11/30/88  
170073

WORK PLAN REVISION  
REVISED FOR PREDESIGN SCOPE, BUDGET, AND SCHEDULE

FIGURE 2  
SCHEDULE  
WORK PLAN REVISION  
ENVIRO-CHEM PREDESIGN

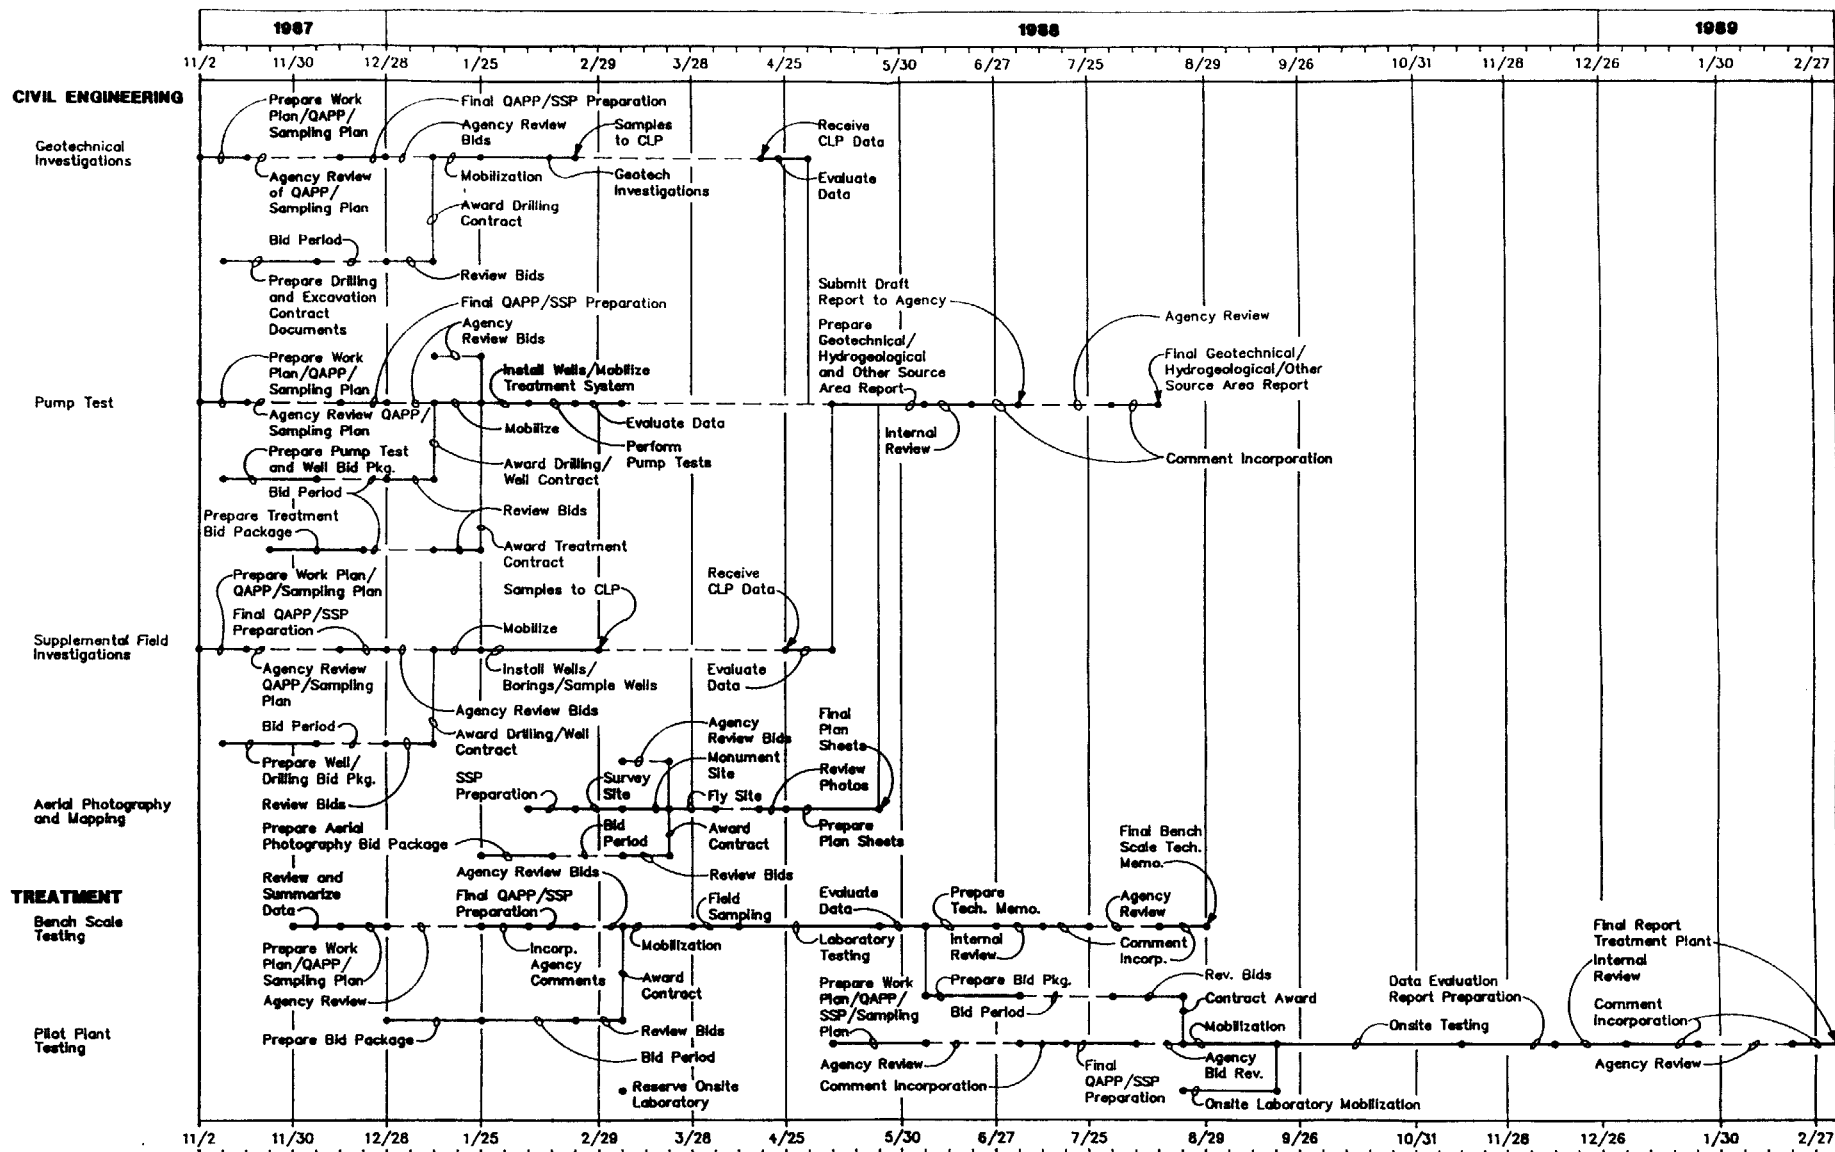
The proposed schedule for the predesign is presented in Figure 2. As shown in Figure 2, the overall civil engineering effort is anticipated to require a 41-week effort. The treatment effort is anticipated to require a 66-week effort. With this schedule the design of the civil engineering elements for the NSL/ECC site remediation could commence as early as the fourth quarter of fiscal 1988. The design of the treatment elements could proceed as early as the second quarter of fiscal 1989.
